**OU1 Design Change and Modification Sheet:
Change/Modification # 34**

Sheet C7, Proposed Bank and Boat Ramp Restoration Plan. Eliminate 8 l.f. of articulated concrete mat (ArmorFlex Mat). The concrete poured at the bottom of the ramp to correct the approach angle necessitates the elimination of the mat section. The additional lineal footage added to the ramp creates a high spot at the top of ramp when tying into the existing grade.
Reference attached drawing.

**SHT. C7
PROPOSED BANK AND BOAT
RAMP RESTORATION PLAN**

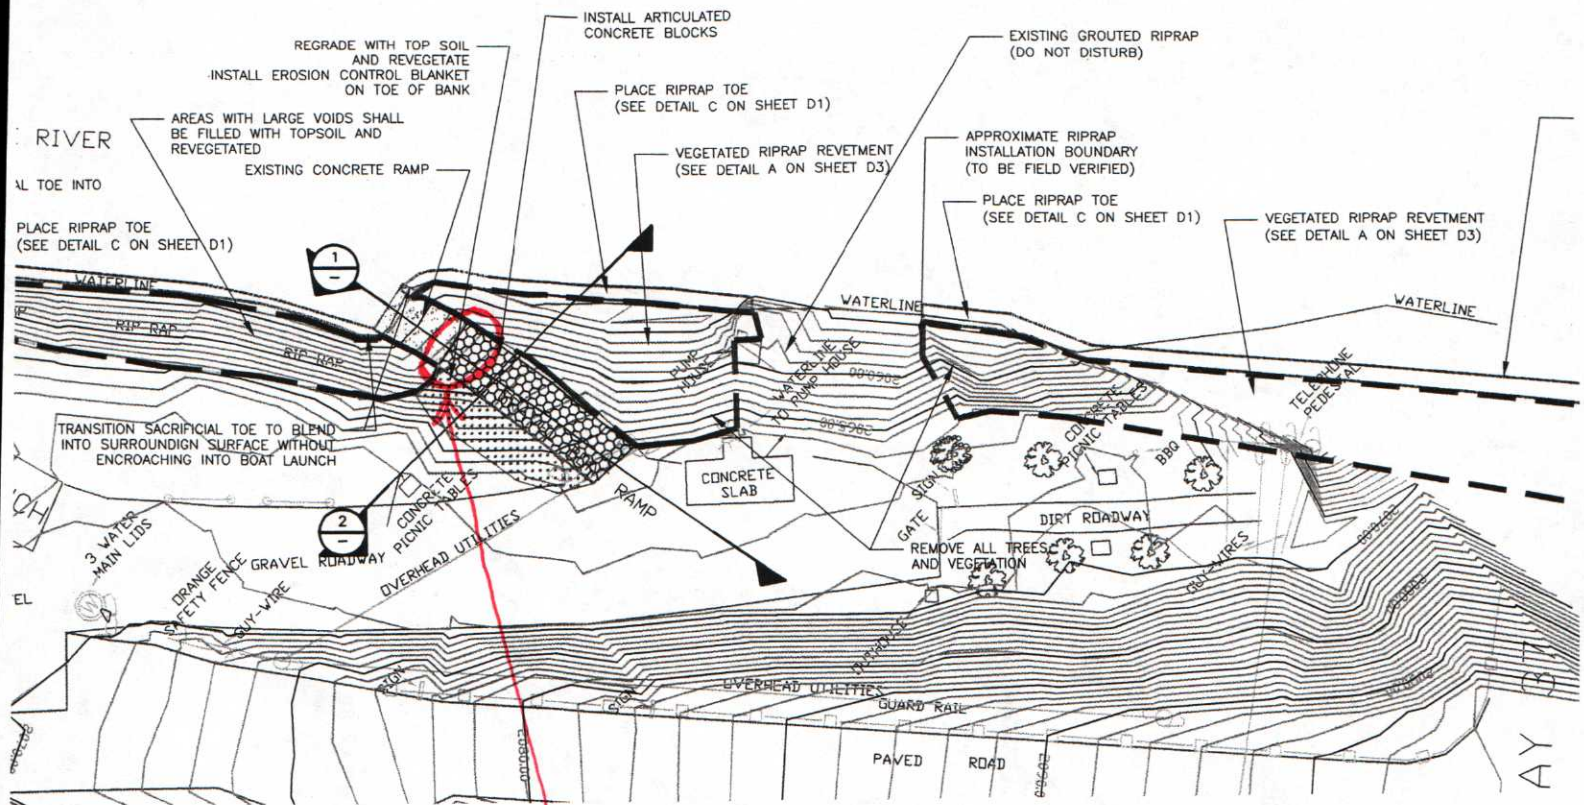
**84% OF ARTICULATED CONCRETE MAT
ELIMINATED, CONCRETED
POURED IN LIEU OF MAT
TO FACILITATE RAMP
ANGLE CORRECTION.**
